Informal document GRE-81-22
(81st GRE, 15-18 April 2019,
agenda item 4)

Simplification of the UN Lighting and Light-signalling Regulations

Poland - response to request SLR for advice

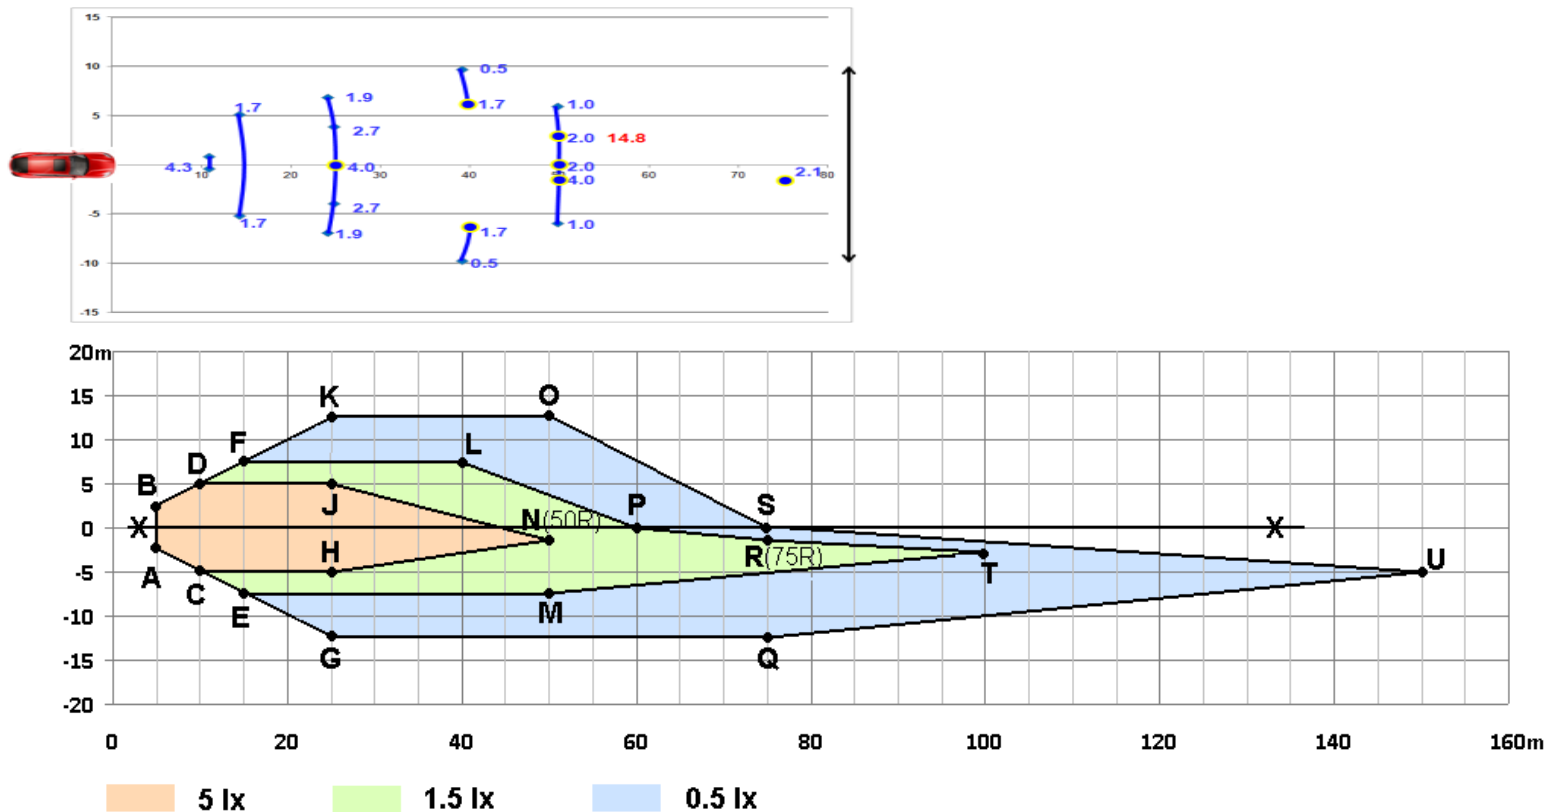
Is it OK to continue having the headlamp provisions expressed on the basis of luminous intensities equivalent to illuminance measured on screen at a distance of 25m?

Is it is incorrectly stated question (**OK** or **NOT OK**).

Provisions should be adequate **to performance** for road illumination and glare exposed eyes area – not for the screen.

For testing it is possible to use equivalent coordinate system – e.g. goniometer angular and intensities. There is no problem to recalculate.

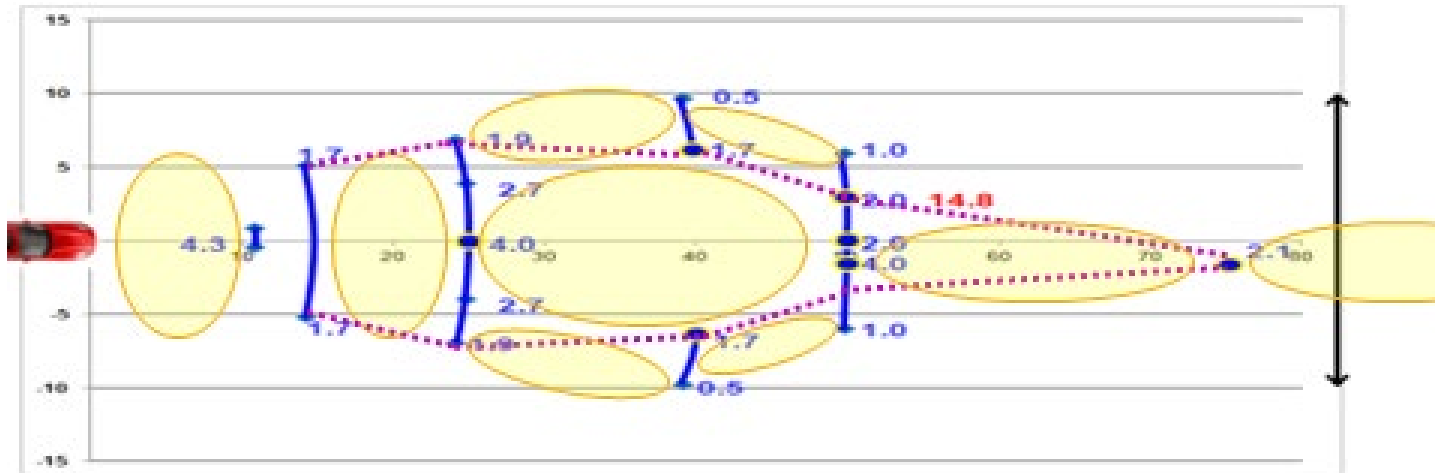
Doubt regarding holes in illumination requirements.

Are holes in light distribution allowed?
